Access Compliance Report

Public Rights-of-Way

(Curb Ramps)

Intersection ID: 3923	Main Street: BRIGHTLEAF_PL	Cross Street: COBBLE_GLEN_WY	Location:	E
ADA ID: C816534ADC94	Ramp Type: Directional1	Initial Pass/Fail: Fail	Overall Compliance: No	Severity Score: 8.75

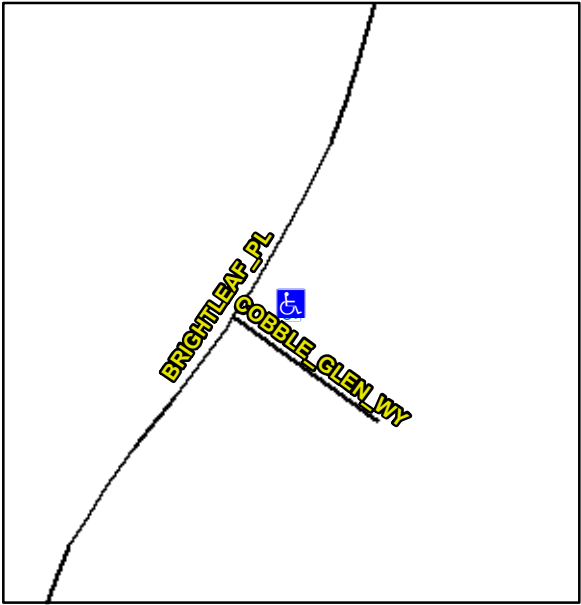
Codes/Mitigation Info/Possible Solution		Field Measurements/Component Compliance					
 <p>Street 1 Name COBBLE GLEN WY</p> <p>Stop Condition-Street 1 StopSign</p> <p>Street 2 Name N/A</p> <p>Stop Condition-Street 2 N/A</p>	Possible Solutions:	Compliance	Description	Data	Compliance	Description	Data
	Remove & Replace Entire Ramp.	N/A	Ramp Length (in)	82.5	N/A	Grade Break?	N/A
		No	Ramp Width (in)	46.5	N/A	Grade Break Slope (%)	0.0
		Yes	Ramp Slope (%)	4.2	N/A	Grade Break XSlope (%)	0.0
		Yes	Ramp XSlope (%)	0.2			
		N/A	Flare Type LT	N/A	N/A	Flare Type RT	N/A
		N/A	Flare Slope LT (%)	N/A	N/A	Flare Slope RT (%)	0.0
	Surveyor Notes:	N/A	Flare Traversable LT?	N/A	N/A	Flare Traversable RT?	N/A
	N/A	N/A	Landing Length (in)	0.0	N/A	DWS Provided?	N/A
		N/A	Landing Width (in)	0.0	N/A	DWS Contrast?	N/A
		N/A	Landing Slope (%)	0.0	N/A	DWS Length (in)	N/A
		N/A	Landing X Slope (%)	0.0	N/A	DWS Full Width?	N/A
	PROW/ADA:	N/A	Landing Curb? (Y/N)	N/A	N/A	DWS Offset LT (in)	N/A

R304.5.1	N/A	Shared Landing?	N/A	N/A	DWS Offset RT (in)	N/A
		N/A	Gutter Ponding?	0.0	N/A	Gutter Slope (%)	N/A
		N/A	Gutter Lip Ht (in)	0.0	N/A	Gutter X Slope (%)	N/A
		N/A	Painted X Walk1?	No		Road Slope (%)	N/A
			X Walk 1 Direction	To SW		Road X Slope (%)	N/A
			X Walk 1 Width (in)	N/A		Clear Space?	N/A
			X Walk 1 Slope (%)	N/A	N/A	Clear Space to XWalk (in)	N/A
			X Walk 1 X Slope (%)	N/A	N/A	Storm Grate/Utility Hazard?	N/A
		N/A	Ramp inside XWalk1?	N/A		Storm Grate/Utility Type	
		N/A	Any Obstructions?	N/A			N/A
			Obstruction Type		Yes	Surface Condition? (G/P)	Good
					N/A	Curb Slope (%)	12.5
Total Cost:		\$	1600.00
